Technical Preservation Services
Preservation Assistance Division
National Park Service
U.S. Department of the Interior
Washington, D.C.

Interpreting the Secretary of the Interior's Standards for Rehabilitation

Volume III

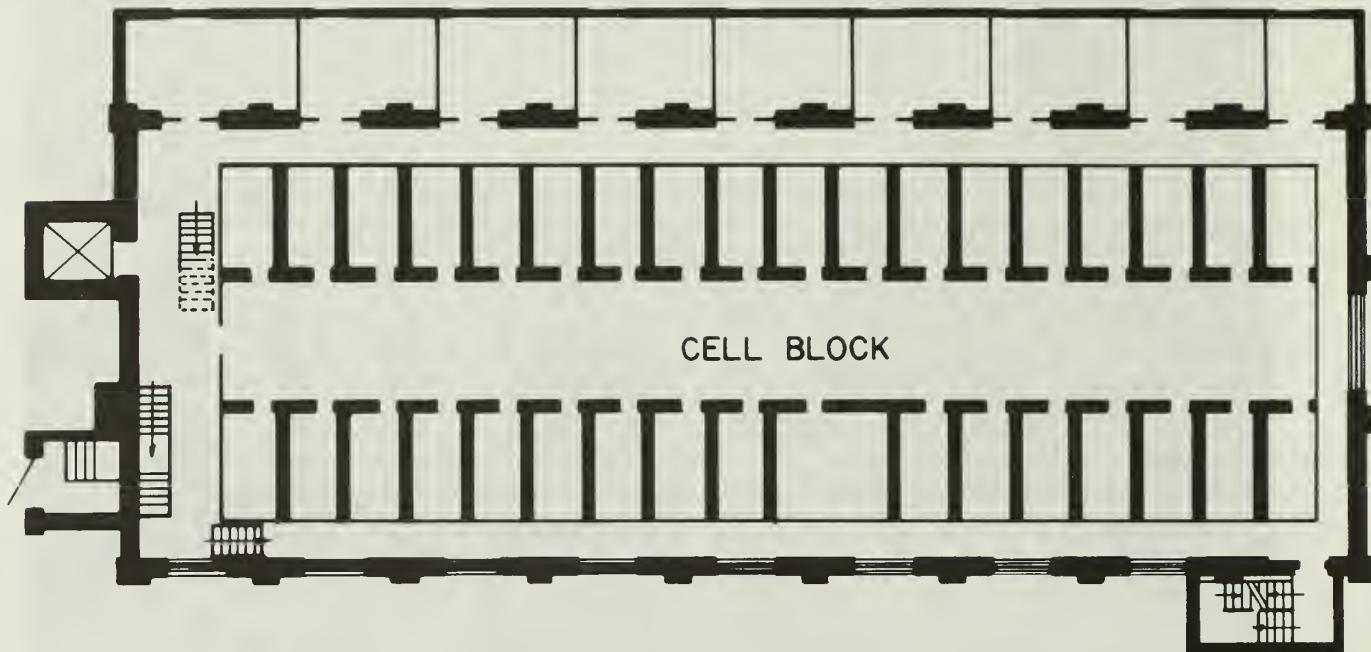
In denying the project certification, the regional office noted that the design proposal would remove:

all signs of the historic plan and structural system along with all interior historic fabric, i.e., stairs, balustrade and newel posts, lattice strap cell doors and riveted steel jambs, etc.
Consequently, this proposal would erase all evidence of the essential form, integrity and sole intent of the building's historic appearance and purpose.

In determining that the rehabilitation did not meet the Standards, the Chief Appeals Officer addressed the underlying question of whether the proposed new use--housing--violated Standard 1 (compatible use). In doing so, he rejected the claim that the conversion of this special-use building to apartments entailed removal of all interior fabric:

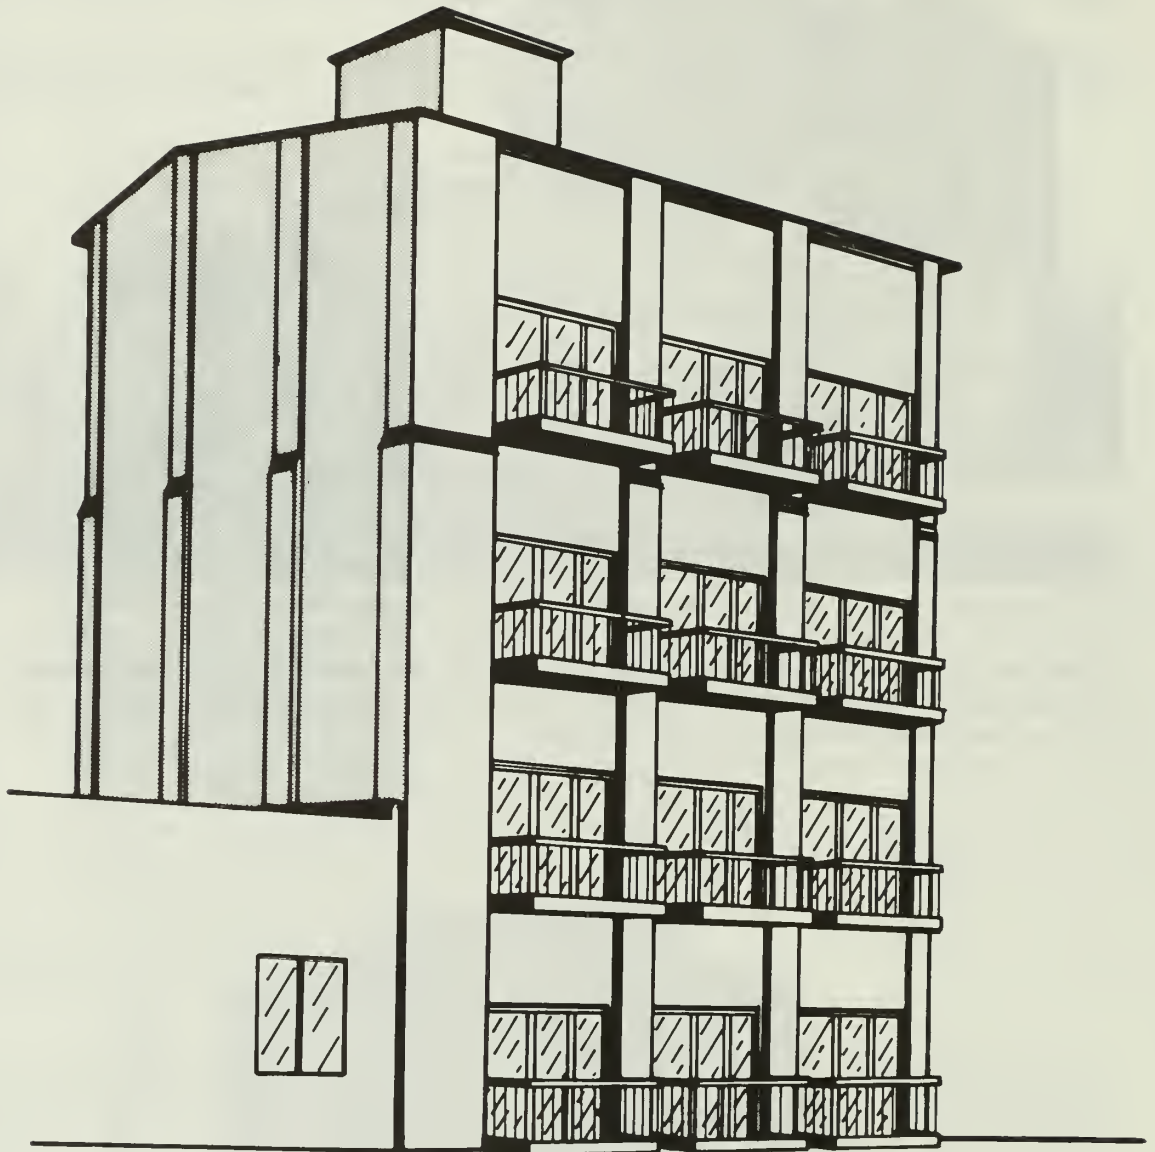
Conversion of an ice-storage building...which will probably be listed in the National Register as a rare example of its type...to use as an apartment building is a drastic change in use and requires too many significant changes to the fabric of the building. The distinguishing character of the main part of the building is inherent in the tall, solid brick walls, unrelieved except by pilasters, without window openings. Cutting window and door openings and adding balconies on four levels on the two long sides of the structure significantly alters the original character...The appended stair towers add to the changes...

1. Photographic documentation showing the hotel after construction in 1907. Distinctive features include a double-decked porch, a series of dormers, and cupola.

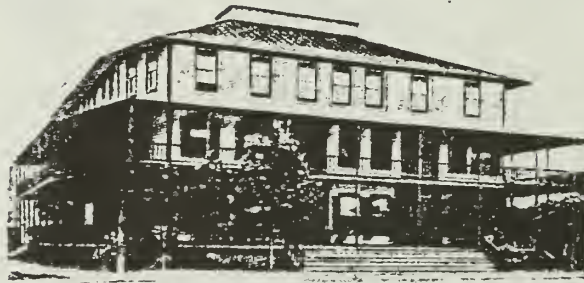
The regional office denied the project for nonconformance with Standards 2, 4, 5, and 6. Removal of a portion of the original porch and alteration of the plan of the upper floors were both cited. Central to the denial, however, was the misuse of photographic documentation to restore two significant architectural features missing at the outset of rehabilitation--the porch and the cupola. The region concluded that the restoration as undertaken could not be justified based on the two photographs submitted with the application. One showed the building after construction in 1907 and the other showed it in 1984. The region's letter stated, in part:

Rehabilitation of the hotel includes the restoration of two prominent significant features of the original hotel, its two-tier porch on all four facades and the central cupola surrounded by a balustrade. Pictorial evidence documents that these features existed in an earlier period; however, the building has evolved over time and the pictorial evidence submitted does not support restoration of the cupola...Restoration of the cupola would create a historic looking building that never existed...Restoration of the two-tier porch is similar to the cupola issue. Documentation does not show that double porches ever existed on all facades after the roof was changed...The cupola and porch proposals represent a selective restoration of original significant features and violate Standards 4 and 6.

In the final paragraphs of this letter, the Chief Appeals Officer suggested that the project might be brought into conformance if the owner would agree to remove the cupola in order to restore the historically valid 1920 appearance of the hotel.

2. 2nd floor plan: Originally a side hall plan with 3 parlor rooms all of similar dimensions. Note extensive new construction in these rooms, especially stair and kitchen in center parlor room, and new wall for bathroom in rear parlor.

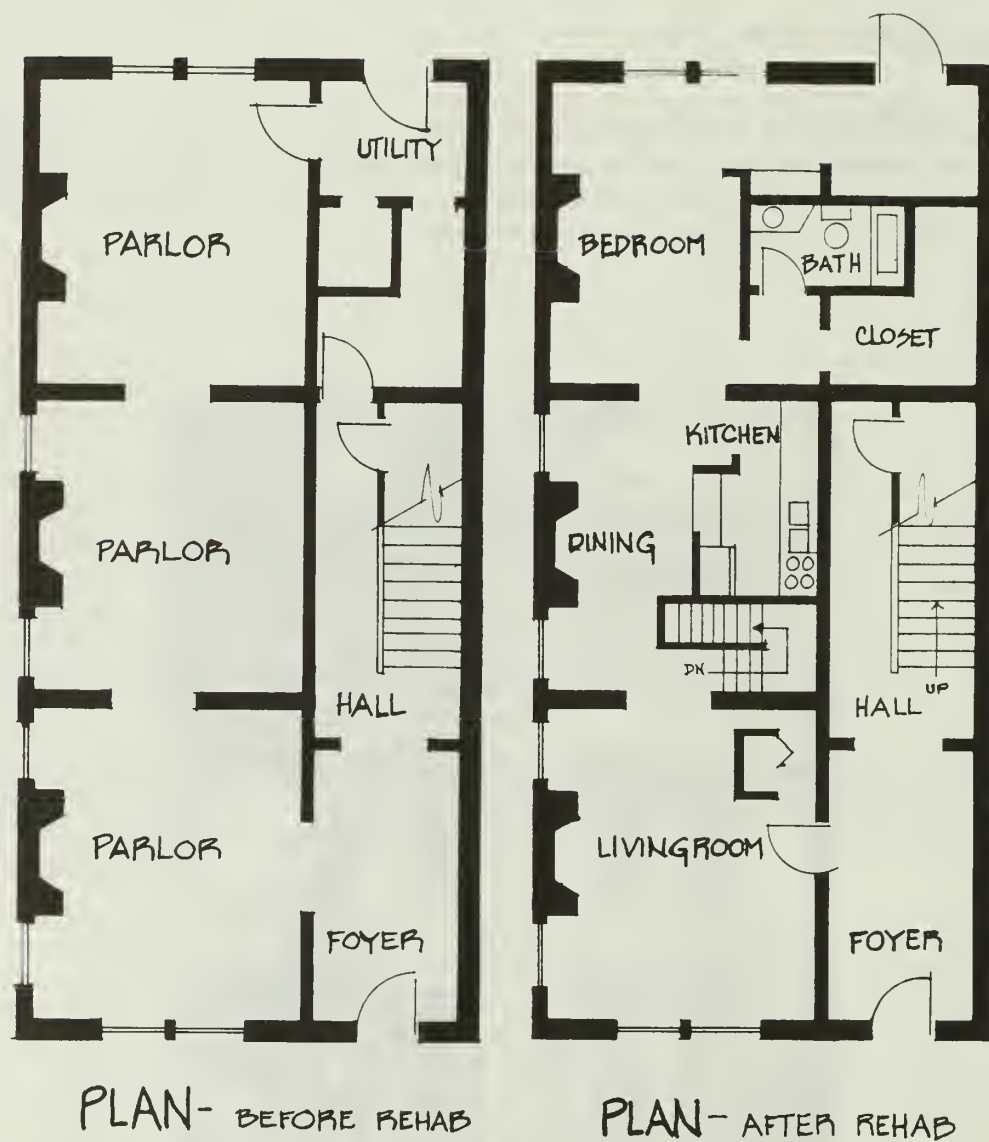
Although it is evident that efforts were made in the rehabilitation to avoid destroying ornamental features such as crown moldings and pocket doors, I find that the alterations have in fact damaged the overall historic character of this building's significant spaces. Although historic interior walls remain on the second floor and in the third and fourth floor hallway, large amounts of historic fabric nevertheless were sacrificed to allow for the new room plan on the third and fourth floors and for the intrusion of three new staircases in the building. I find the alterations to the parlor floor the most destructive. The three formal rooms, historically of approximately equal size, have been significantly altered by new construction. The new construction in the center room, effecting the most severe intervention in terms of the amount of new building and loss of historic fabric, has further altered the original spatial qualities of the second floor overall. Although the rear room is still partially visible from the front room, I find the new kitchen wall and stair balustrade in the center room so invasive as to destroy the sequence of space that this series of rooms was consciously designed to envelope. The alteration to the parlor floor is sufficiently

damaging to the character of this building that I would have upheld the regional office on that change alone. Therefore, it is my determination that the rehabilitation is not consistent with the historic character of the building and that it fails to meet Standards 2, 5, 9, 10.

Original Plan
1st Floor

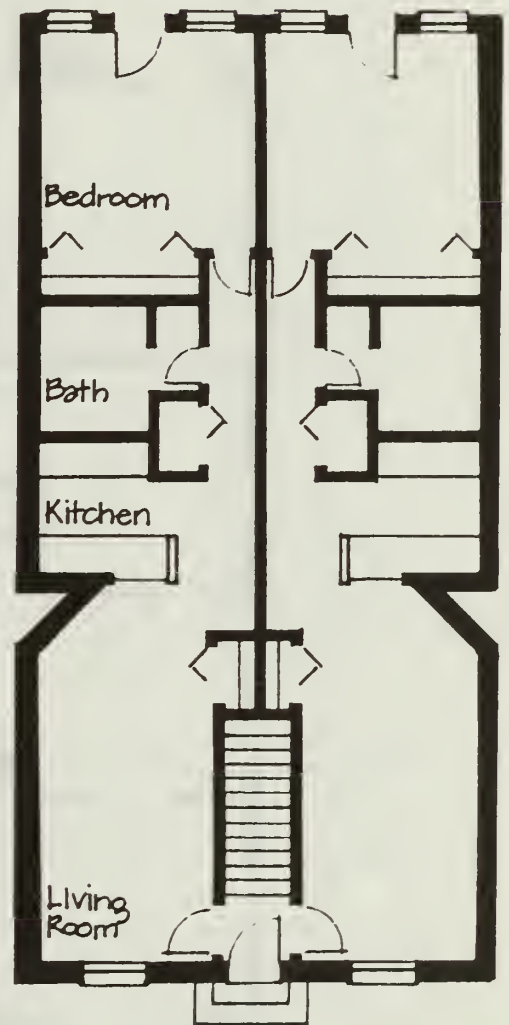
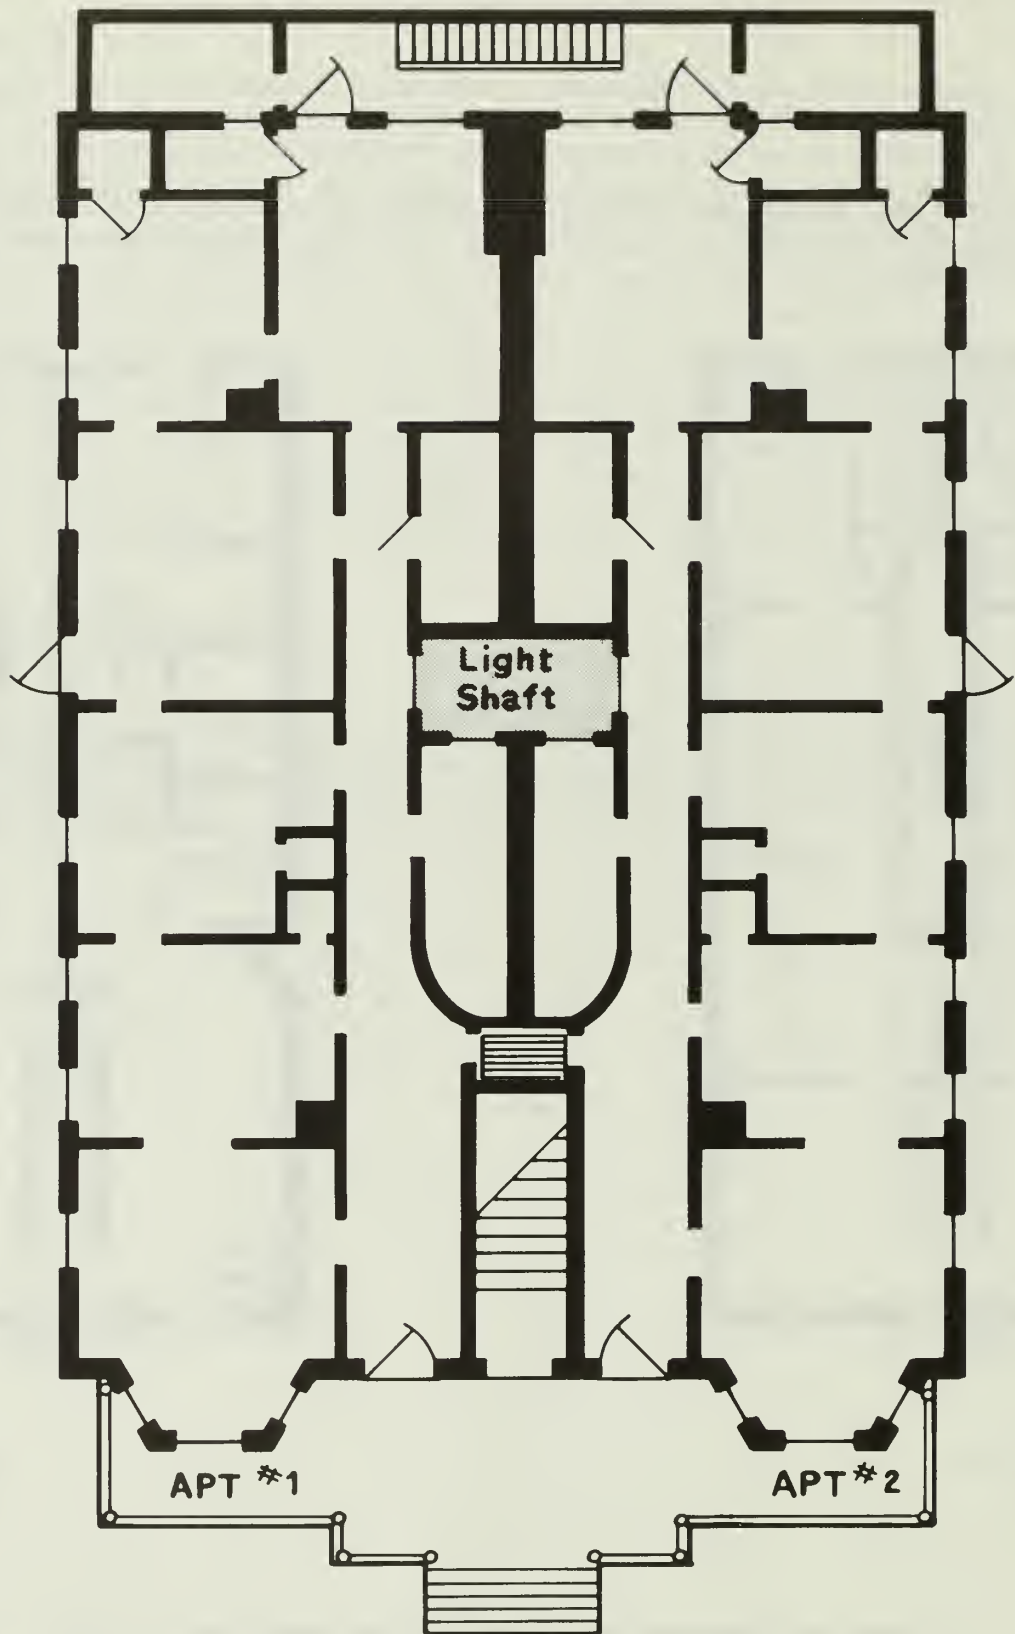
1. Original floor plan showing the two first floor "flats" separated by center staircase and lightshaft. Note that lightshaft was completely enclosed, and not visible from the rear of the building.

2. New floor plan after rehabilitation shows that although lightshaft has been eliminated, basic concept of "railroad flat" remains.

6a and 6b. After rehabilitation floor plan of 1890 building. The unit on the left now extends across the full width of the building in the rear half. To regain the floor space thus lost in the right unit, a stair was added, further altering the plan of this simple structure.

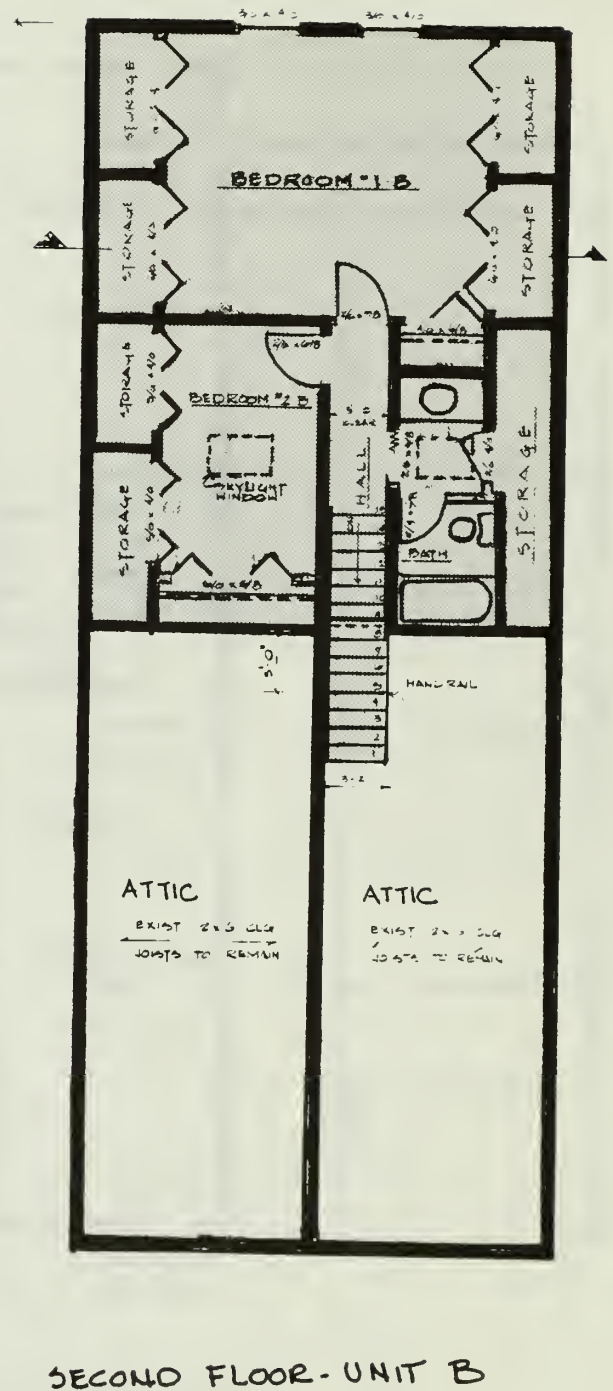
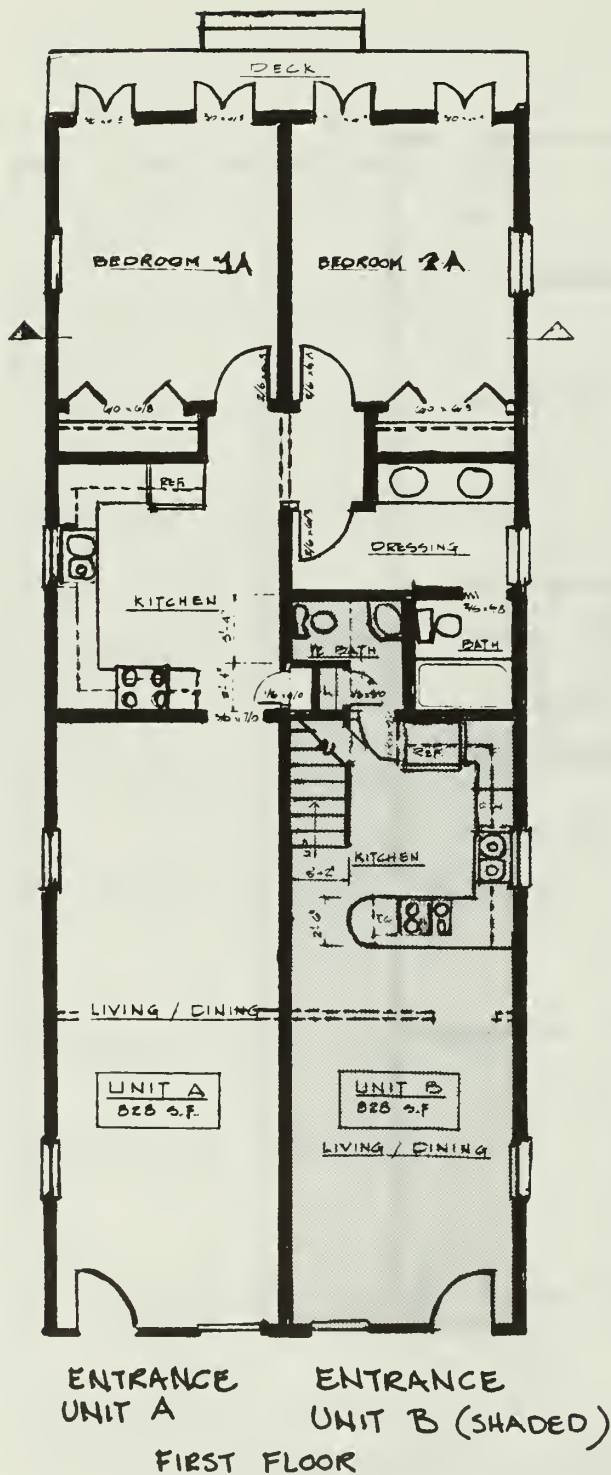
In the second case, radical changes made during the rehabilitation obliterated the characteristic interior plan (see illus. 6). The separation between the two front rooms was destroyed to create one larger room in place of the double parlor arrangement. In

order to enlarge the apartments, the plan was further altered by incorporating almost the entire rear half of the right unit into the left unit. The floor space lost to the right unit was regained through the addition of a stair to the attic, into which two bedrooms were added. In this project the damage done to the historic character of this modest building is extreme. The units no longer convey a sense of the original "shotgun" plan. Construction of the stair in the right unit has further drastically altered the structure by introducing a vertical element missing from the historic plan. Finally, the division between the halves of the building was effectively destroyed in the rear half of the building. Accordingly, the project fails to meet the Secretary of the Interior's "Standards for Rehabilitation."

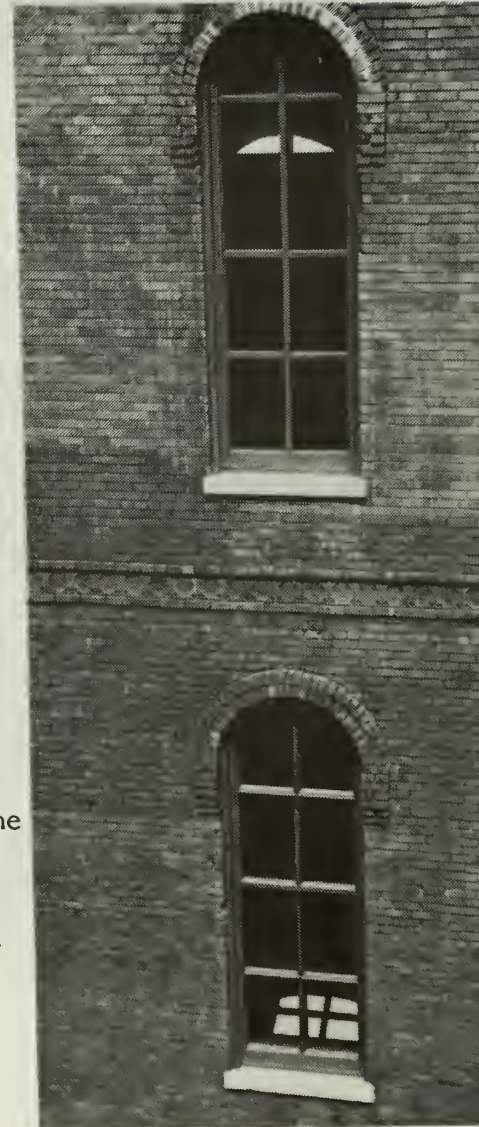
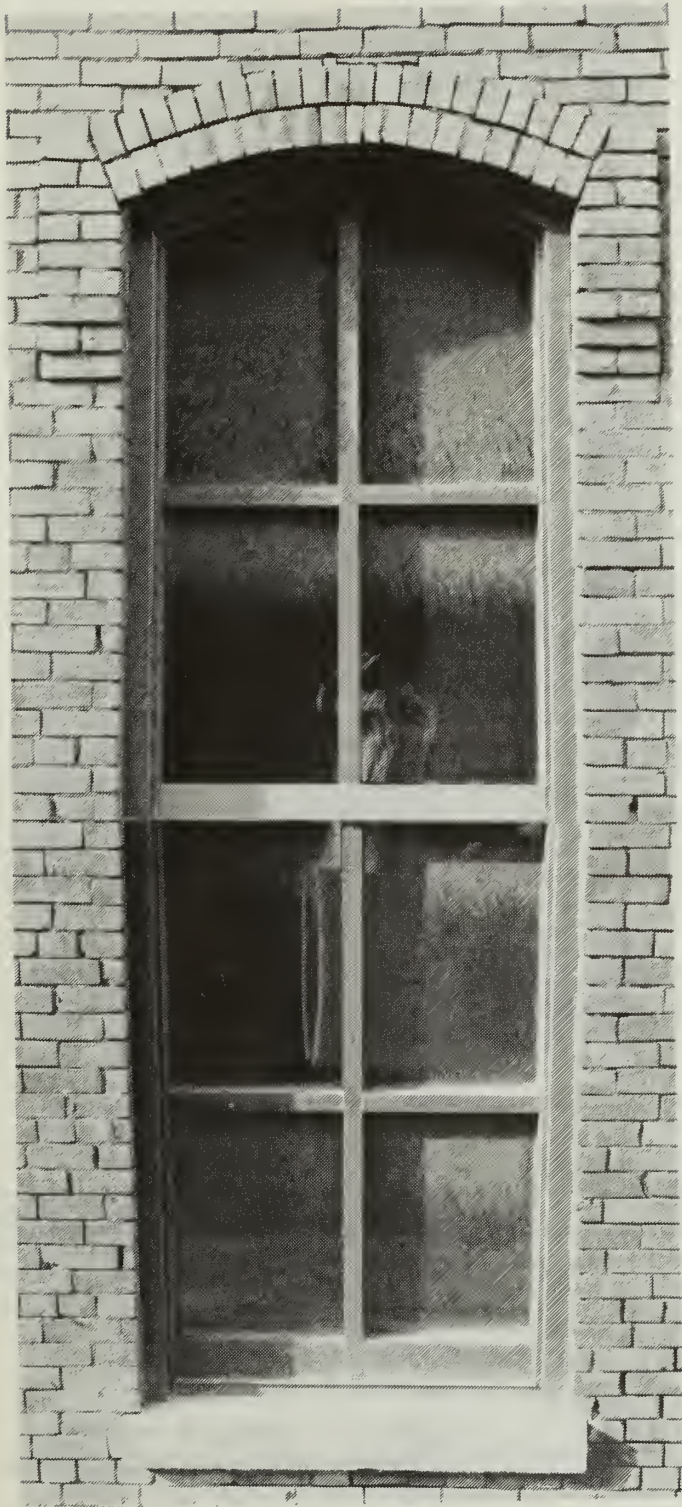
Before and after photographs revealed several design deficiencies in the new window. Where one over one double-hung windows had existed historically on the building's primary facade, the replacement windows were a "fixed" design with both upper and lower sash on the same plane; the horizontal piece applied as a meeting rail is actually flat, and consequently unable to cast the familiar shadow line of the historic window. Finally, there was a dramatic difference in color, from a light cream color to dark brown (see illus. 1 and 2). On another key facade, where there had been historic four-over-four double-hung windows, fixed sash were installed, the light divisions were altered, wider muntins were used, and the color of the windows was changed (see illus. 3, 4 and 5).
